Addendum # 001

TENDER NUMBER: 612-CP2108

Rear Yard Site Improvements

Christ the King Catholic School

DRAWING TITLE:
SITE GRADING PLAN

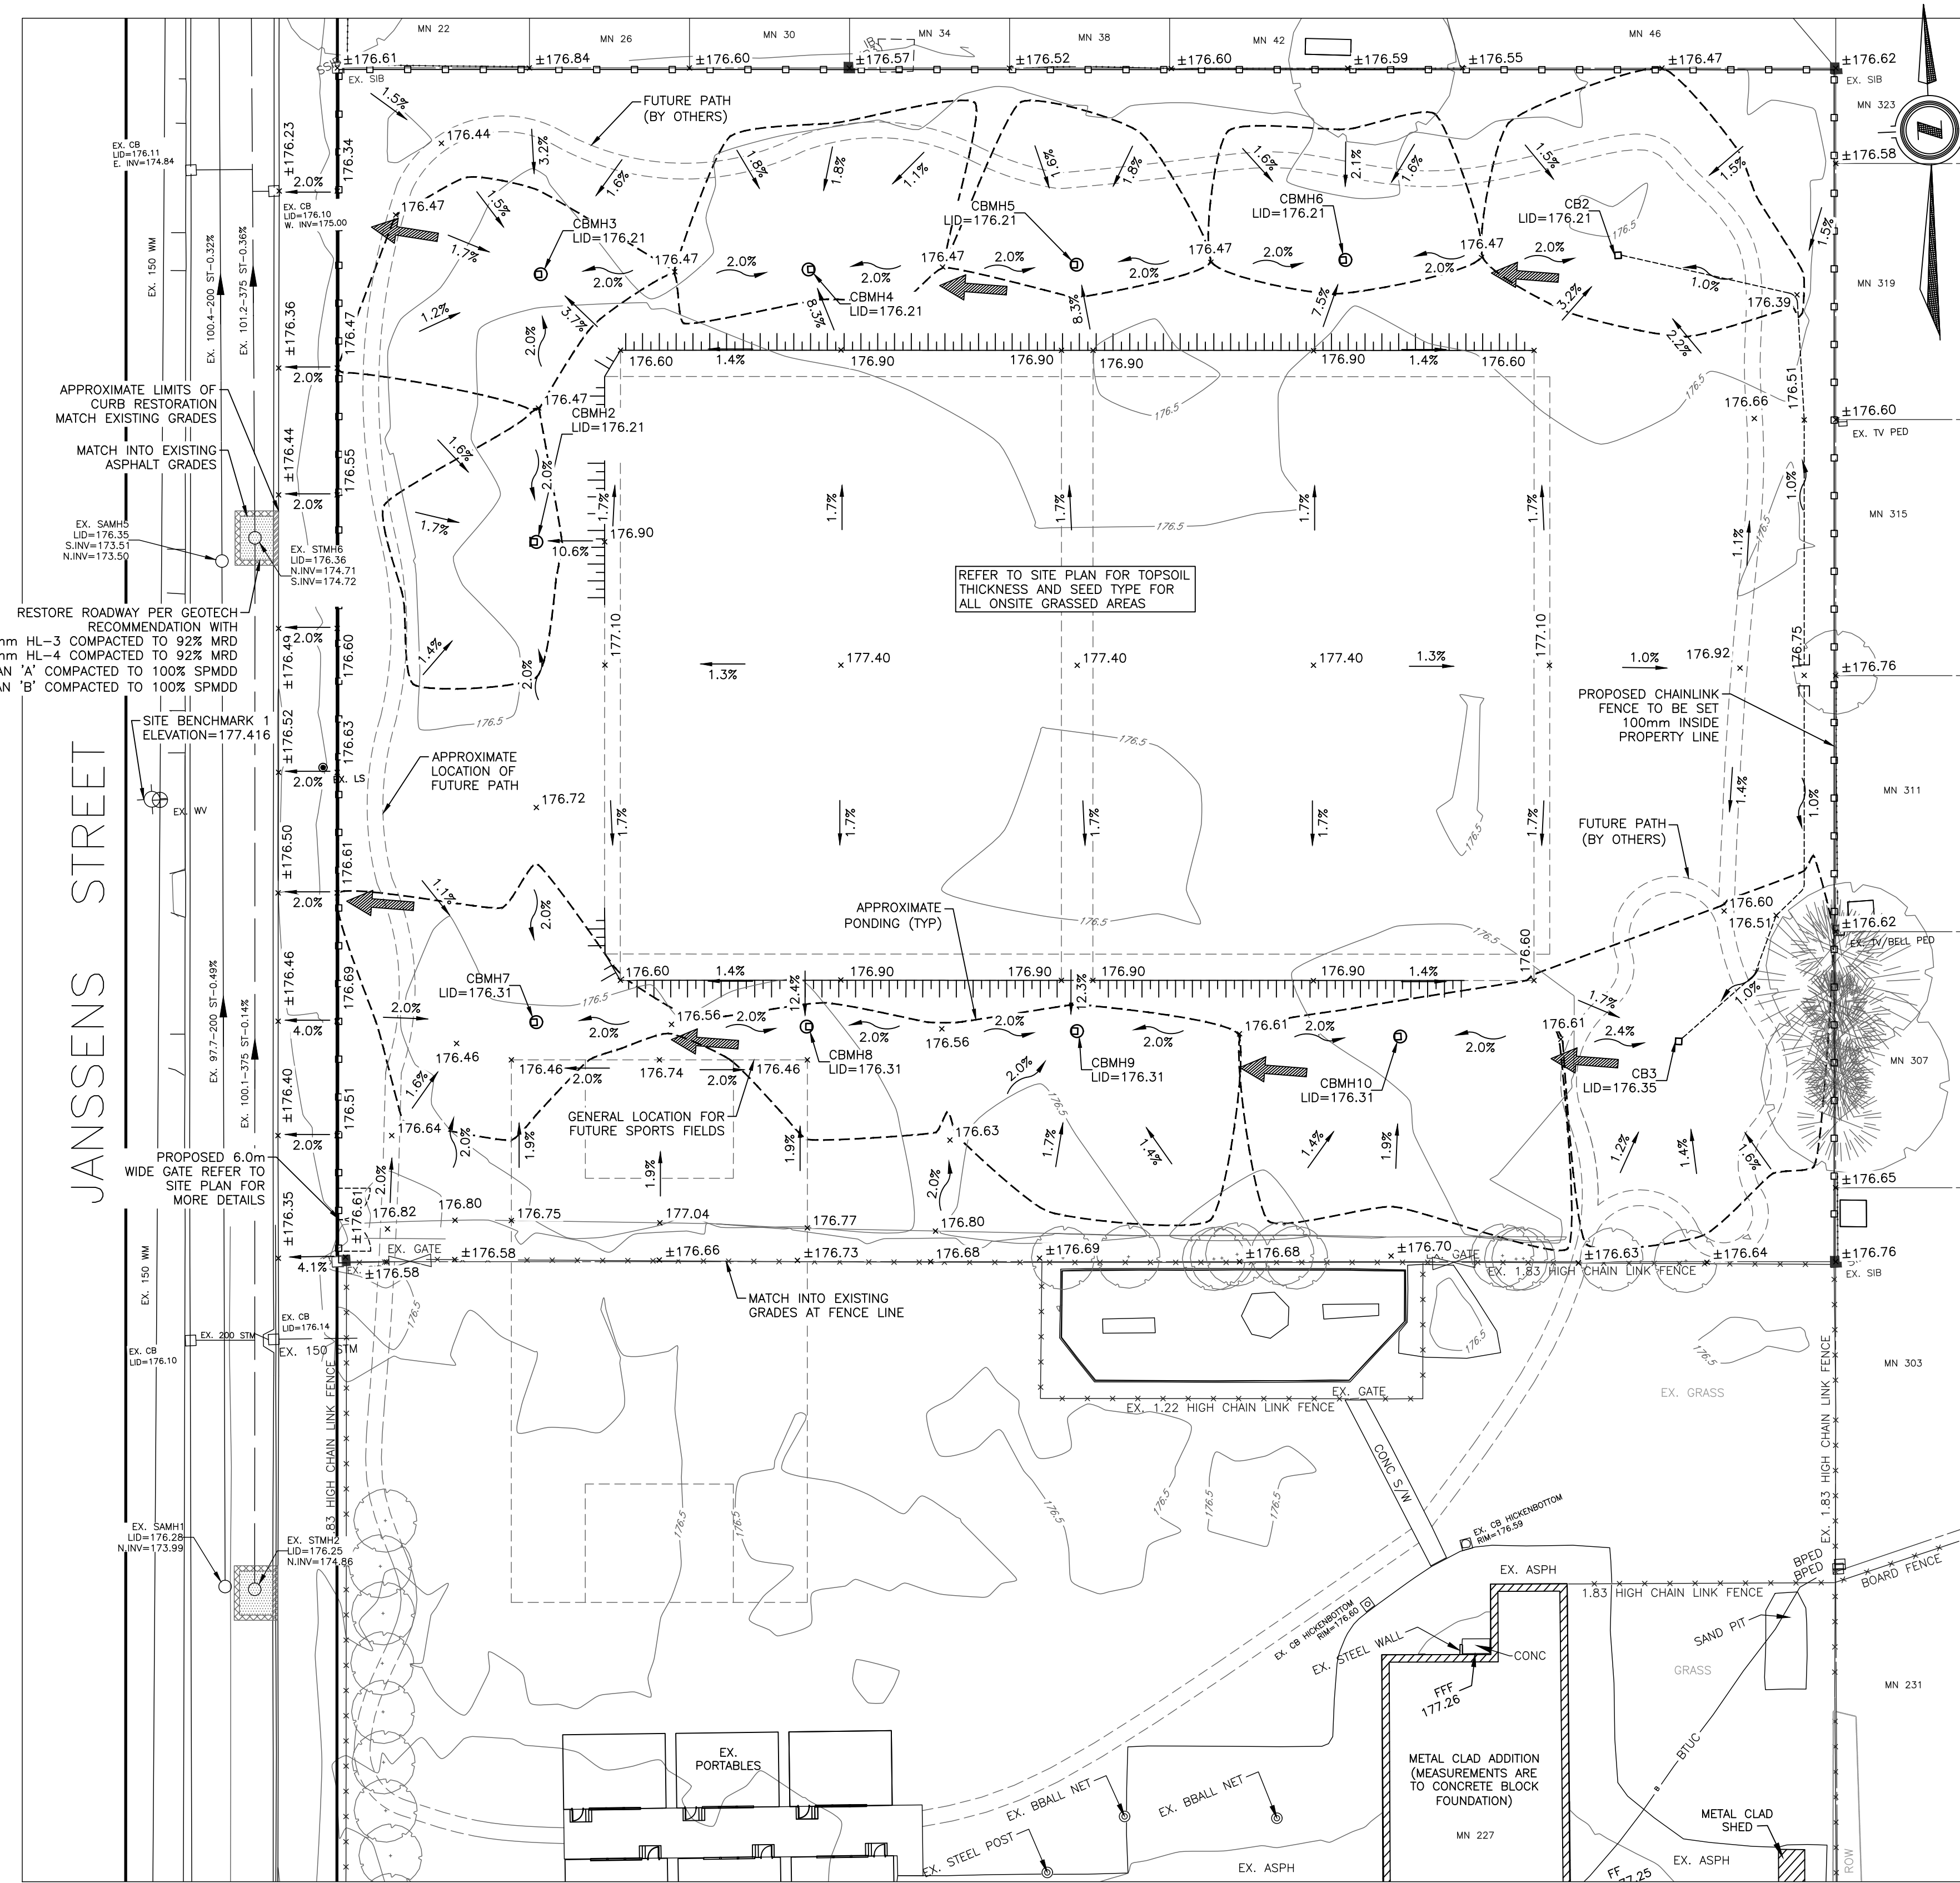
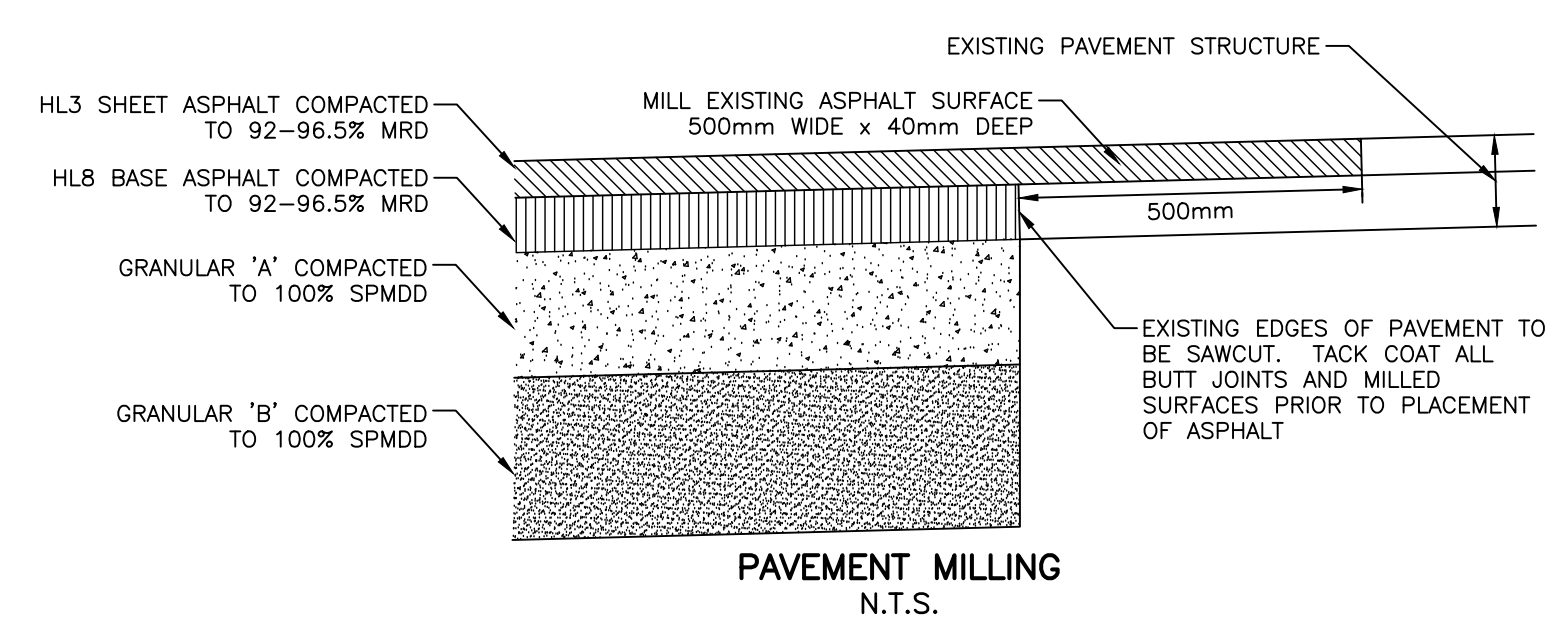
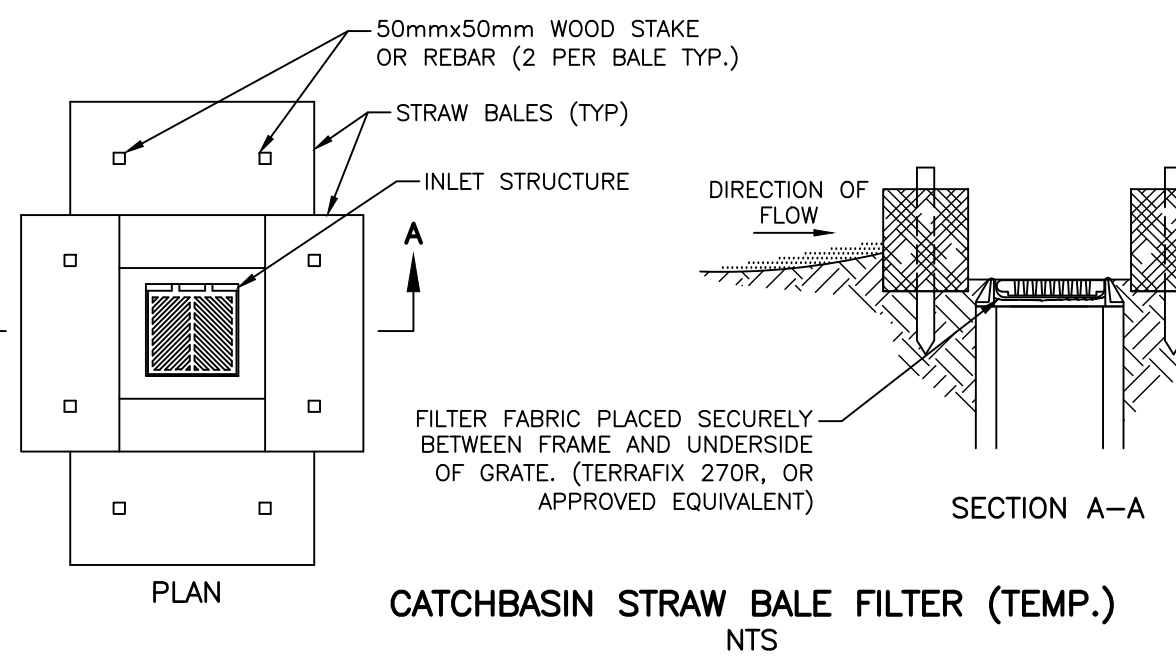
- A3:** The two wells are only water level monitoring wells. Refer to Geotechnical report.
- Q4:** Can you please clarify the intent of the final grading on page SE3? Is the scope of work to include grass removal, regrading and reseeding to the area that I have bubbled as attached? Or are we only to repair what is damaged due to the drain installation?

- A4:** Scope of grading and servicing works has been revised to include only the north field area. No servicing and grading is proposed within the existing play area south of the existing fence. Refer to the appended revised Civil Drawings.
